**City of Bellevue  
Development Services Department  
Land Use Staff Report**

**Proposal Name:** Myhrvold Bulkhead Repair

**Proposal Description:** Application for a Critical Areas Land Use Permit associated with removal of an existing vertical timber bulkhead and soldier piling to be replaced with a battered rock bulkhead, beach cove and gravel beach which spans the property located on Lake Washington. A Shoreline Exemption Letter (13-107282-WE) is associated with this approval.

**File Number:** 12-117676-LO

**Figure 1**

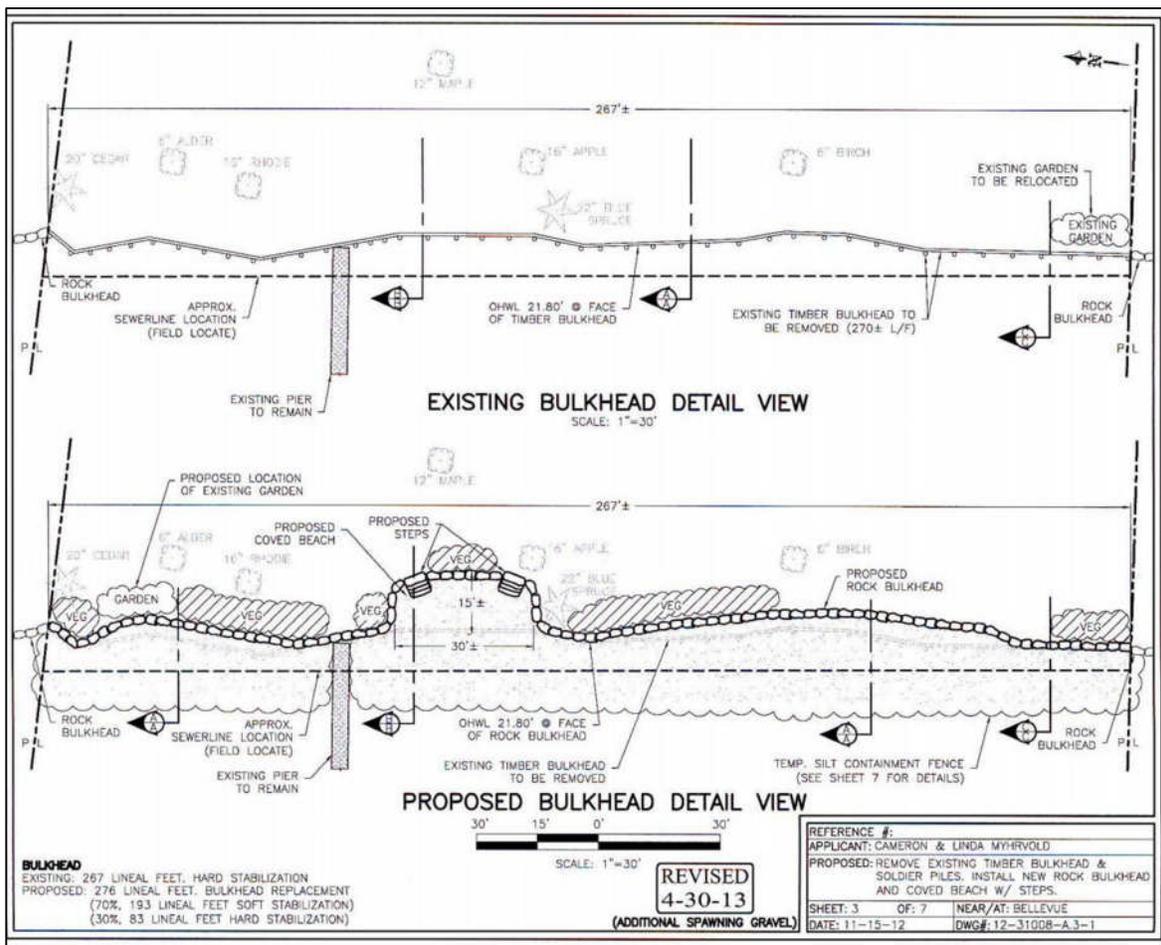
The applicant proposes to remove an existing vertical timber bulkhead and replace it with a batter rock bulkhead, beach cove, and gravel beach. Shoreline planting totaling 1, 386 square feet is also proposed. The existing wall will be removed and the shoreline will be moved landward where a new battered rock wall will be constructed. A 30-foot wide by 15 feet long beach cove will be created along the shoreline. A gravel beach will be installed in front of the new bulkhead with 335 cubic yards of gravel spanning the lake frontage of the property. Figure 1 below show the existing shoreline and the proposed replacement.
